In addition to my other objections, I am submitting a further objection to the application 2022/3525 (Molesey Venture Site, Orchard Lane, East Molesey) in response to the applicant's Flood Risk Assessment Addendum submitted 26th Sept 2023 by KRS Enviro and the new information that the EA will not consider the risk of groundwater flooding as it is outside their remit. There are 3 points that I would like to raise:

(1) Topography, New Structures and Impact on Conveyance Routes

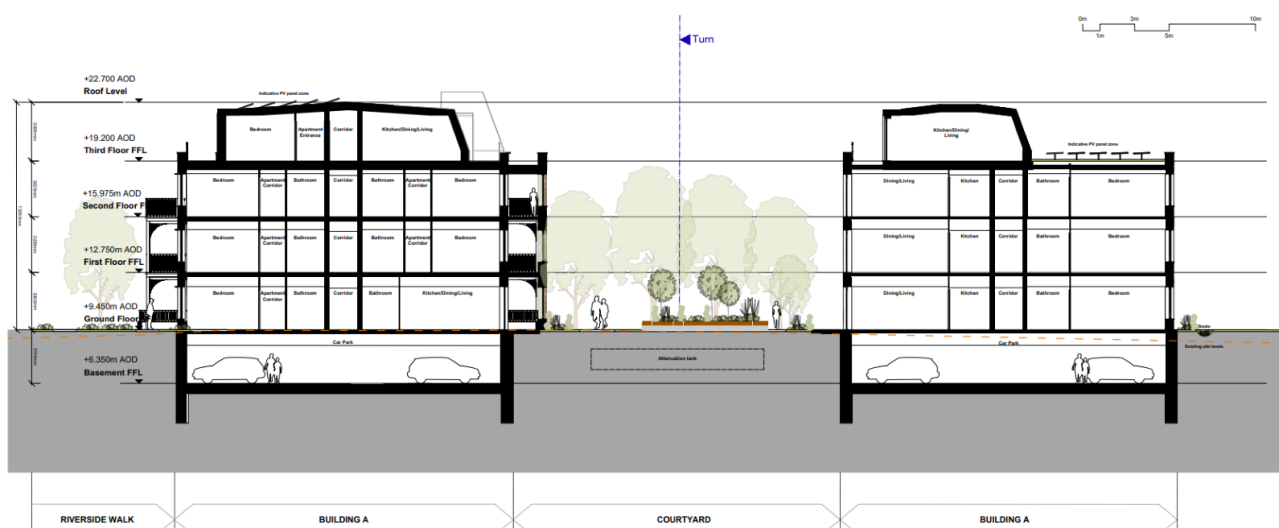
(i) According to the applicant's own data **the development will indeed alter the topography of the site**. As the letter itself states: *"The finished floor levels of the buildings and landscaped areas immediately adjacent to the buildings will be raised to 9.45AOD"*. Meanwhile the applicant's flood risk assessment (dated 26.6.23) has a topographical survey for the site in appendix 2. This shows that current heights vary across the site. On the north east of the site around the current greenhouses and horticultural centre heights range from 8.6AOD to 9.09AOD. Building A and the surrounding land will be raised by +4-10% above the prevailing heights. Building A – proposed sections AA supplied by the applicant details the increase in heights shown by the red dotted line below.
